Access Compliance Report

Public Rights-of-Way

(Curb Ramps)

Intersection ID: N/A	Main Street: INVERNESS_BAY_RD	Cross Street: OBAN_PASSAGE_DR	Location: NE
ADA ID: C791A2E7C0A7	Ramp Type: Perp	Initial Pass/Fail: Fail	Overall Compliance: No
Codes/Mitigation Info/Possible Solution		Field Measurements/Component Compliance	
Severity Score: 21.25

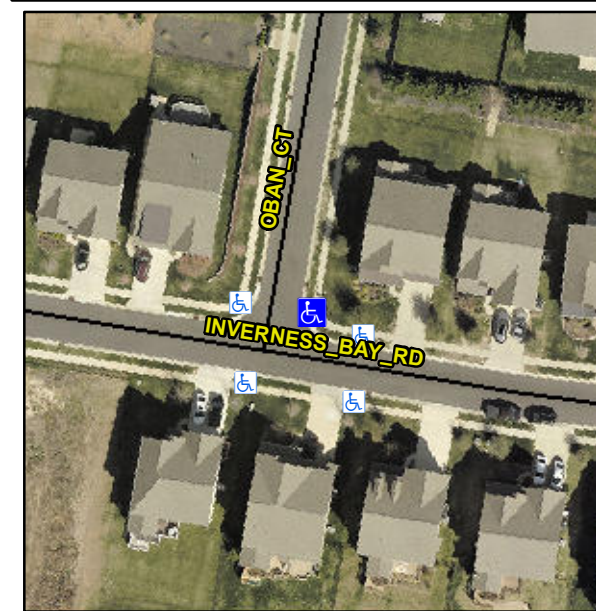
Not Found, R304.5.1, R304.5.3

Remove & Replace Entire Ramp.
